TECHNICAL NOTE

2020s1712
Review of Drainage Strategy for Thames Farm,
Shiplake
Shiplake Parish Council
21/07/2021 S3-P02
Paul Eccleston / Brendon McFadden
Paul Eccleston / Brendon McFadden
Review of revised Flood Risk Appraisal and
Drainage Strategy, July 2021

1 Introduction

Figure 2-1: Ground elevations from proposed pumping station to outfall

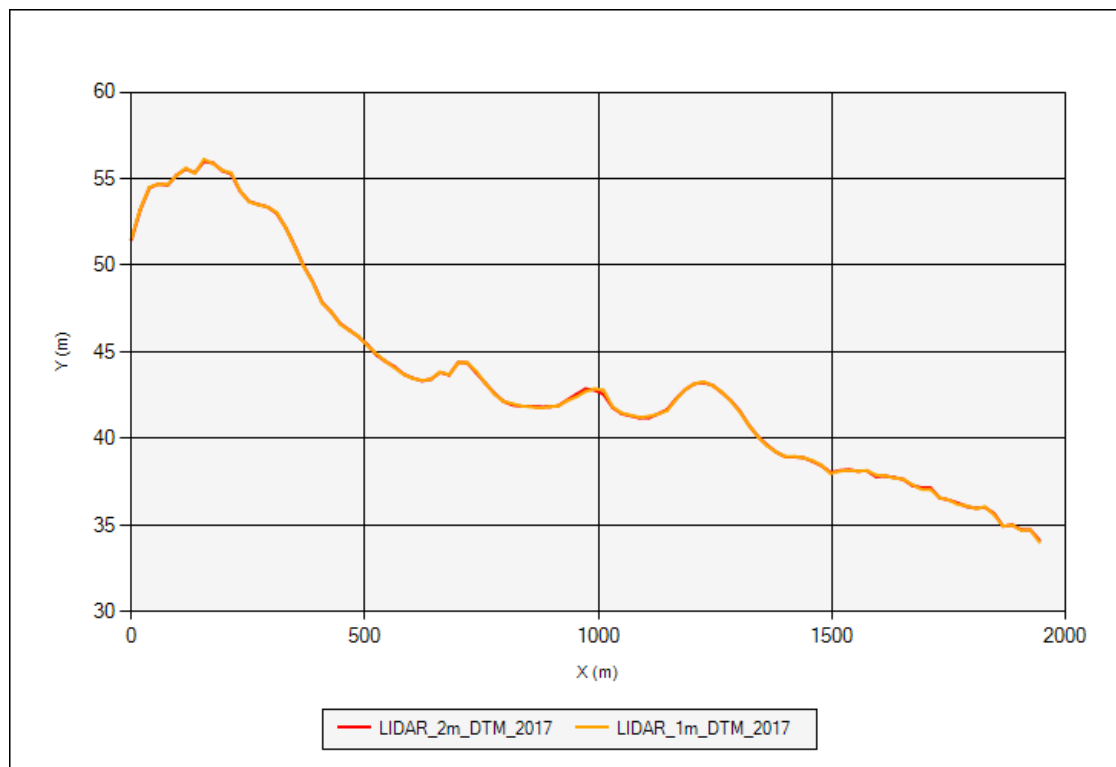
- A pumped discharge solution is selected "Due to the A4155 Reading Road being topographically higher than the Site some 800m north of the site access road." (s5.38). No long section of this option has been provided (although a long section of the rejected Option 2 to the Lash Brook is included). We have made an approximate check of the long-section using the layout shown on page 35 and Environment Agency LiDAR terrain model (Figure 2-1). This shows that whilst there are some small "lumps" in the profile along Reading Road, they wouldn't preclude a gravity sewer, although this would need to be laid deeper beneath these sections. It is likely that the design has prioritised the lower capital costs of building a rising main when compared to a gravity sewer. The high operating costs of pumping all surface water for the lifetime of the development will be passed to Thames Water and its bill payers once the sewer has been adopted. There is no evidence of whole-life costing or hydraulic calculations to justify the selection of a pumped system.

Figure 4-1 - Site footprint in relation to groundwater abstraction borehole SPZ

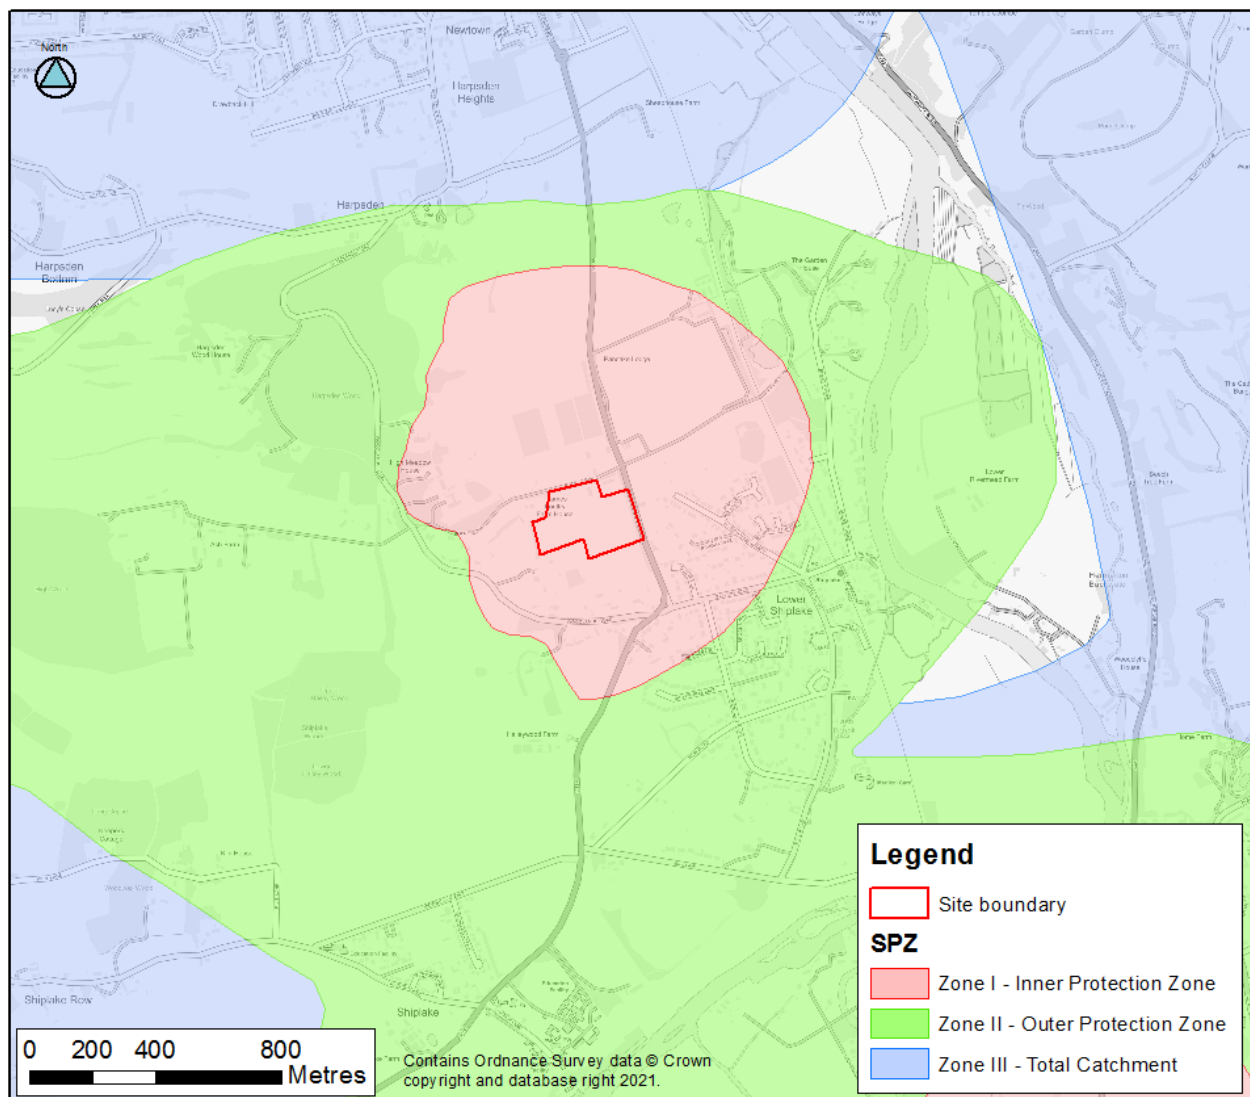
It is noted that the report does not use the most up to date SPZ mapping (see latest SPZ outlines in Figure 4-1).

- Increase the likelihood of the borehole being affected by pollution incidents,
- Put new SPZ 1 restrictions on the uses of parcels of land formally not subject to them, reducing their potential utility. This also relates to Policy ENV12 detailed above, which states that there should not be significant adverse impacts on the amenity of neighbouring uses. The SPZ 1 area is approximately 1,280,000 m² while the site footprint is 57,300 m² (see Figure 4-1), which is approximately 4.5% of the SPZ 1 area.

Figure 2-1: Surface water flow pathways and site layout

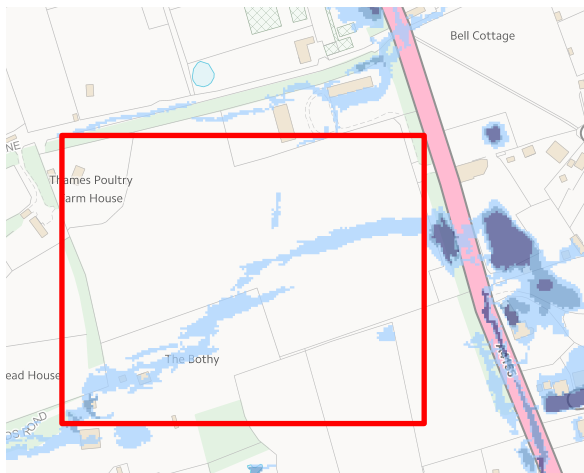
- Section 3.2 identifies the two surface water flow pathways running west to east along the site's northern edge and approximately through the centre of the site. However, as our previous review noted, neither the site layout nor the drainage arrangements are designed around these pathways. This brings into question the standard of protection offered by the drainage design, particularly when considering failure of drainage systems (say due to blockage or pump station failure) and runoff onto the site from upstream. It is long-standing principle of SuDS drainage that the site's natural flow pathways should be maintained when setting out the site layout, rather than building houses across them as is the case here.

- The southern surface water flow pathway onto the site (shown in Figure 2-1) has the potential to bring in runoff from outside of the site and subsequently for this water to enter the site's drainage system. No allowance for such runoff has been made, and as discussed in section 2.1, the layout of the site has not been planned to allow for this flow pathway.

Figure 3-2: Comparison of newly modelled and existing flood outlines

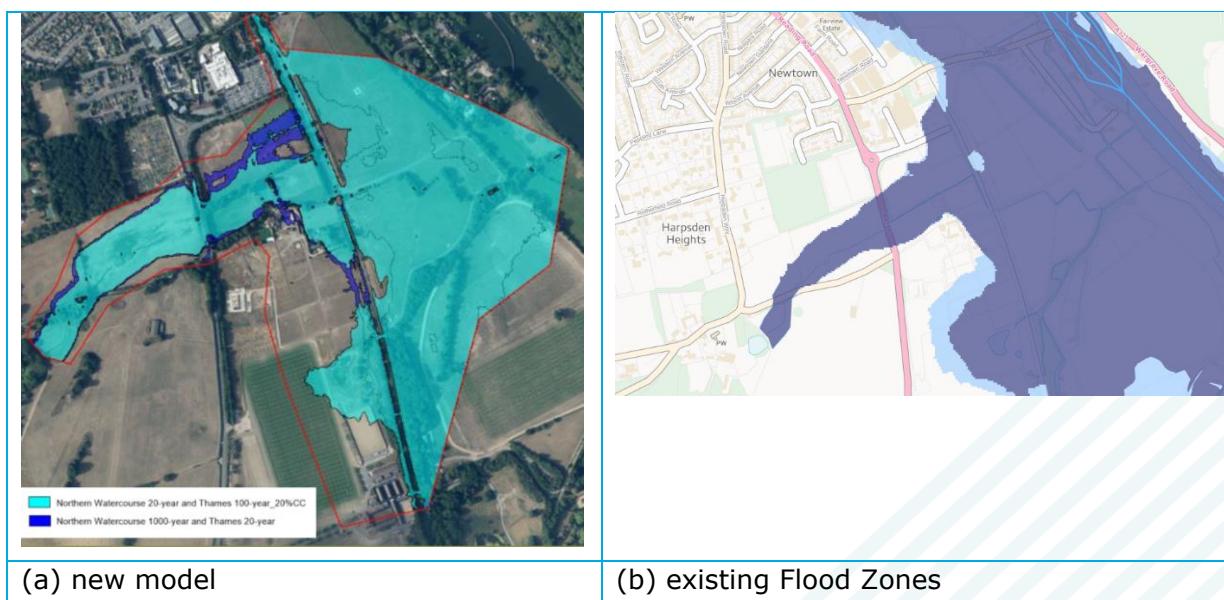
- The new flood outlines are broadly similar to the existing Flood Zones. The main differences appear to be due to the use of more detailed LiDAR terrain data available to the 2021 study (see Figure 3-2).
